Scio Planning Commission – In Person & Electronic Meeting

1. *Public Hearing: PL2021-02* – Randy Nelson/Iceland Construction – Subdivision Re-plat 10S01W18AC, Tax Lot 0900
Presented by: Dave Kinney, Planning Consultant
2. *PL2021-03* – SMTA – Property Line Adjustment 10S01W18AD, Tax Lots 5100, 5200 and 5300
Presented by: Dave Kinney, Planning Consultant
3. Planning Commission Vacancy

SCIO PLANNING COMMISSION **STAFF REPORT**

COVER SHEET
TENTATIVE SUBDIVISION
10S-01W-18AC TAX LOT 900
Scio, Oregon

Sheet **C102**
SCALE: SEE BARSCALE

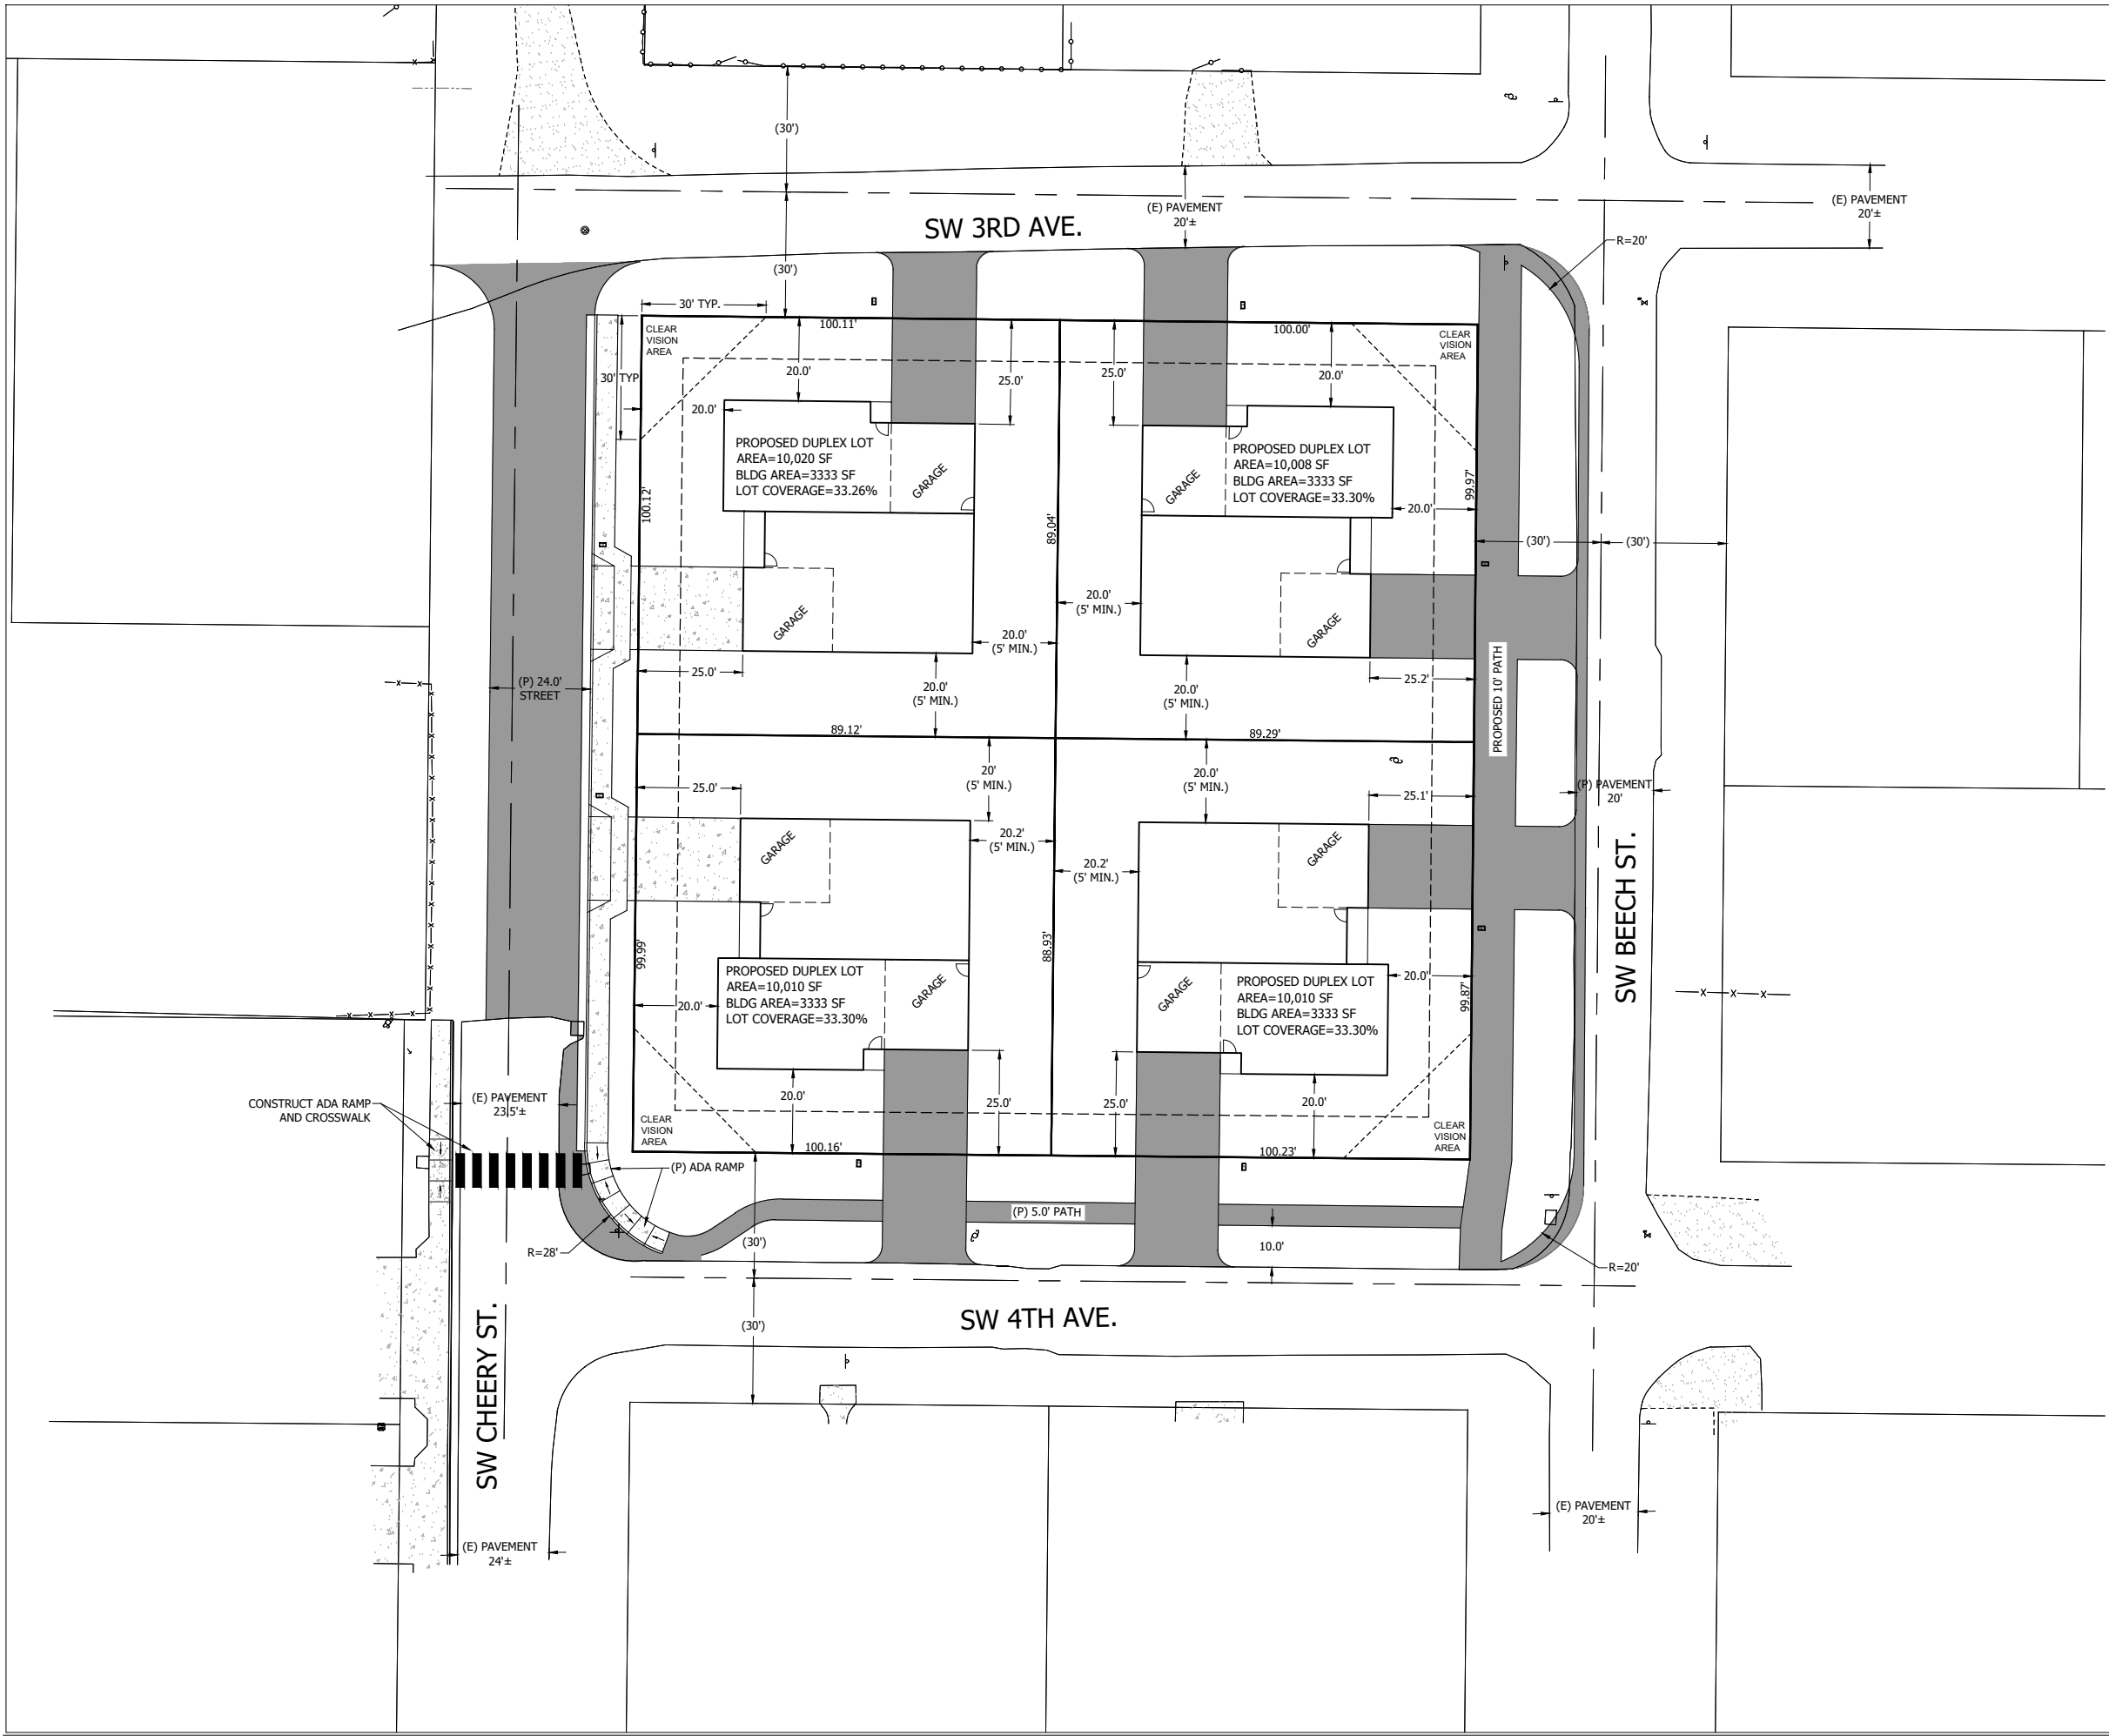
- 3.110 (1) Sheet C102 shows four 10,000+ square foot building lots. Each lot will have a minimum 100' frontage along the front lot line of each duplex, which exceeds the minimum 80' lot frontage requirement.
- 3.110 (2) The applicant's site plan shows four duplexes, one on each lot. Sheet C103 shows a conceptual site plan; each building lot will have a 3,333 SF building area, a 20' front setback to the face of building and a 25' setback to the front of the garage. Lot coverage will be <35%.

Conclusion: Sheet C102 shows the new lots comply with lot size requirements. Sheet C103 shows duplexes can comply with the setback and lot coverage requirements. *The proposal complies with the basic zoning requirements found in Article 3, Sections 3.110 to 3.160 "Multi-family Residential Zone".*

- a. PUE: Sheet C102 shows a 10' PUE along the street frontage for all lots.
- b. Storm Drainage Easement: Sheet C105 shows storm water from SW 3rd Ave., SW 4th Ave. and SW Beech Street will flow onto the property and then discharge to the storm sewer on SW Cherry Street. The City Planner recommends a storm drainage easement be granted to authorize the City to enter the site to maintain the inlets/outlets.

1. Provide a 10' wide PUE on the street frontage boundary for all lots.
2. Provide a storm drainage easement to the City (area to be defined on the final plat).

Sheet **C103**

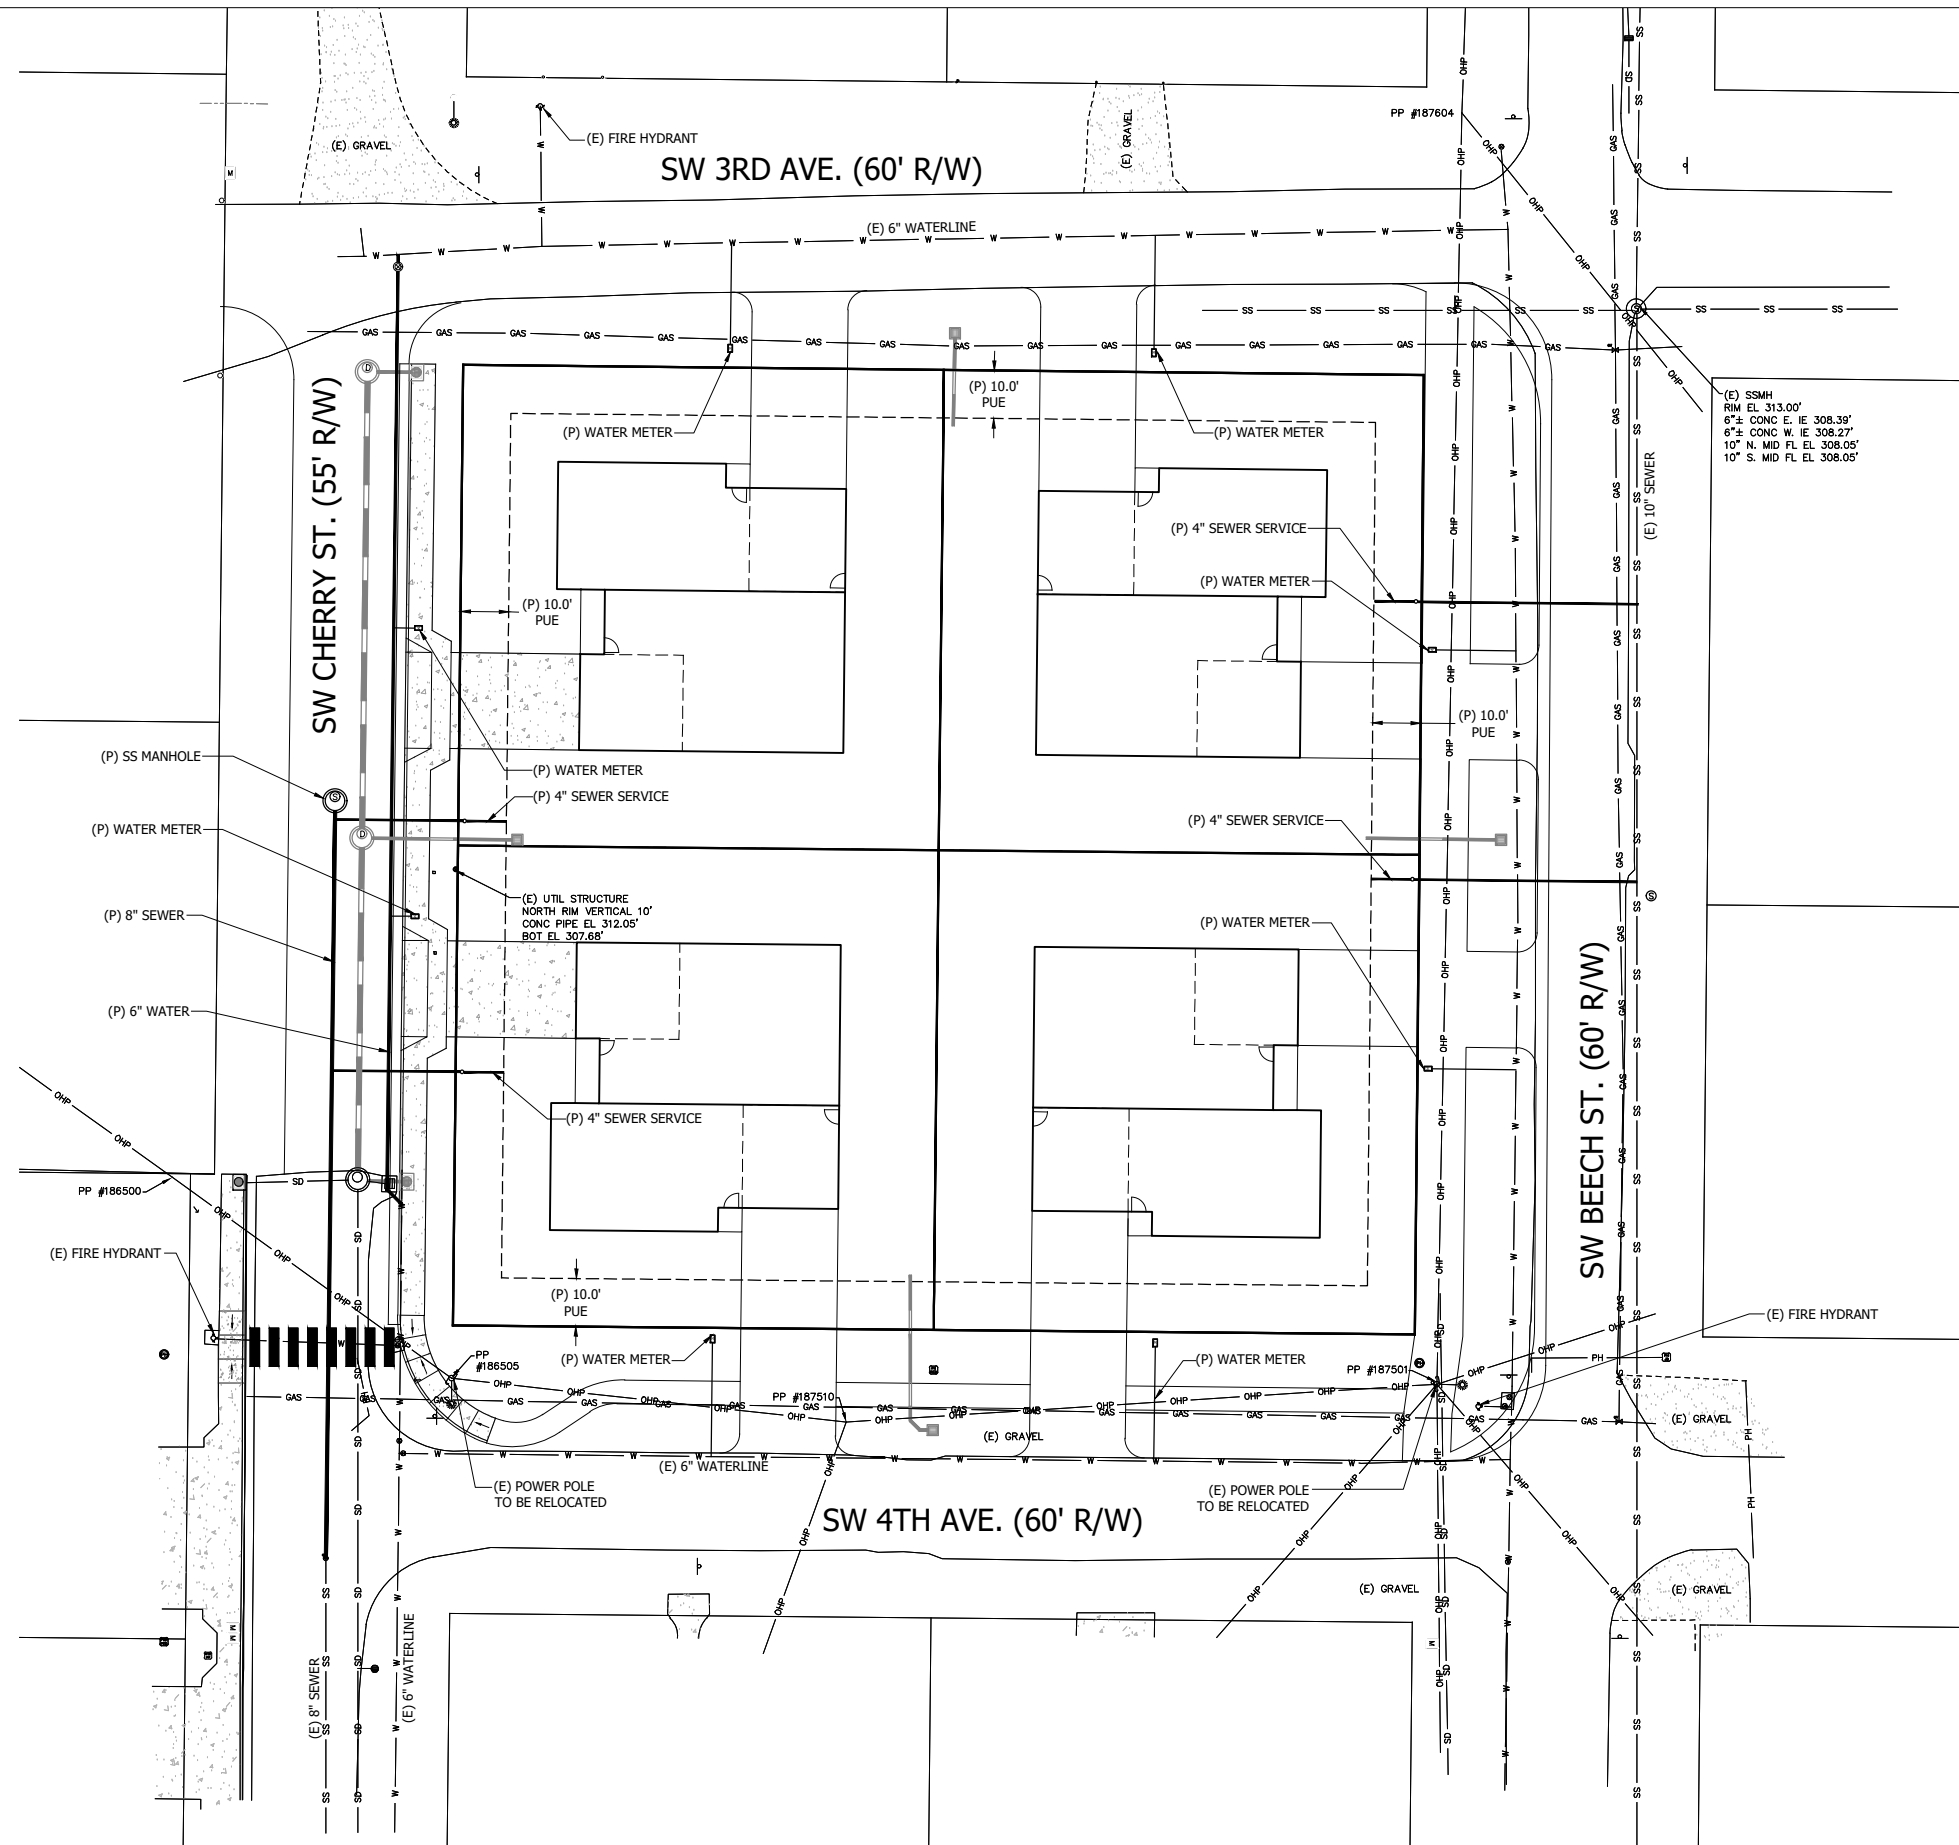
- V-9 On Sheet C103, the applicant proposes the following street improvements:
- SW Cherry Street: ¾ street with curbs, gutters, pavement and sidewalks (east side).
 - SW 3rd Avenue: No street improvements. Utilize existing turnpike street. No sidewalk or pedestrian path improvements.
 - SW 4th Avenue: No street improvements. Utilize existing turnpike street. Add a 5’-wide AC pedestrian path.
 - SW Beech Street: AC pavement widening to 20’ pavement width. Construct a

Sheet C103 includes the applicant's proposed street improvements. In Exhibit B, the City Engineer reviewed Sheet C103 and recommends the following improvements in order to comply with the City's public street standards:

Sidewalks/Pedestrian Path: The City Engineer recommends modifications to the plans to provide for sidewalk improvements to better serve students walking to/from schools.

13.020.M Street Lights. The plans do not show street lights. There is no street light at the corner of SW 3rd & SW Beech Street. A new street light shall be installed on the existing power pole at the NW corner of SW 3rd and SW Beech Street. The final engineering plan shall show proposed street lights and type for approval by the City.

Design and construct the following street improvements, subject to final engineering plans review and approval by the City Engineer:
